802.1ASbt overview on
asCapable hair-trigger issue for
Clause 11 (MD layer for FullDup P2P links)

Bob Noseworthy (ren@iol.unh.edu)
University of New Hampshire's
InterOperability Laboratory (UNH-IOL)
IEEE 802.1 TSN TG
2014.05.14

The MDPdelayReq State Machine (Fig 11-8 per 802.1AS-cor)

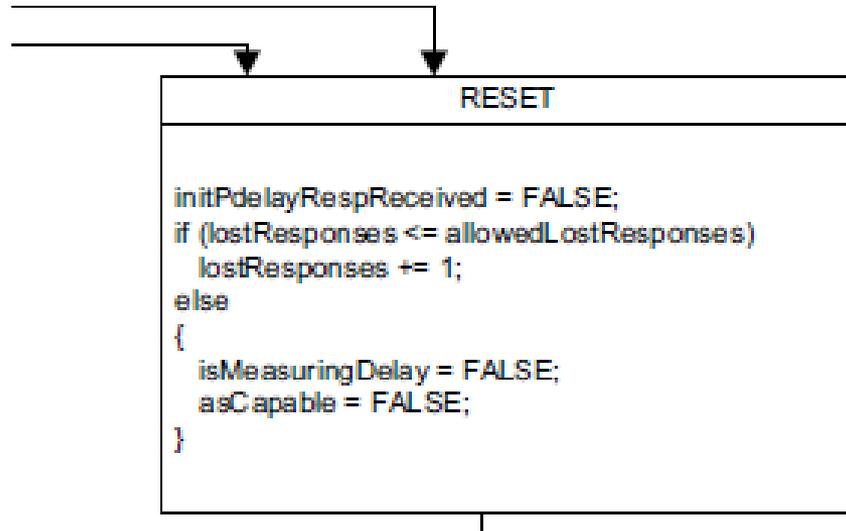
- Focus is on the if-else block
- A single violation of the 3 conditions result in asCapable being set FALSE at anytime.

```
if ((neighborPropDelay <= neighborPropDelayThresh) &&  
    (rcvdPdelayRespPtr->sourcePortIdentity.clockIdentity !=  
    thisClock) && neighborRateRatioValid)
```

- neighborPropDelay
 - Left to implementation to define, this could ‘momentarily’ be set above the threshold by system fault, time stamp uncertainty, etc if sufficient averaging is not being performed
- rcvdPdelayRespPtr->sourcePortIdentity.clockIdentity
 - Sensitive to a single received error in the received Pdelay Resp (but it is impossible to reach this state if the value is !thisClock)
 - Recommendation: Delete this condition
- neighborRateRatioValid:
 - Left to implementation to define, should define ‘wisely’ to never glitch

- Consideration should be given to increasing the value of allowedLostResponses (currently 3), which also sets asCapable to FALSE
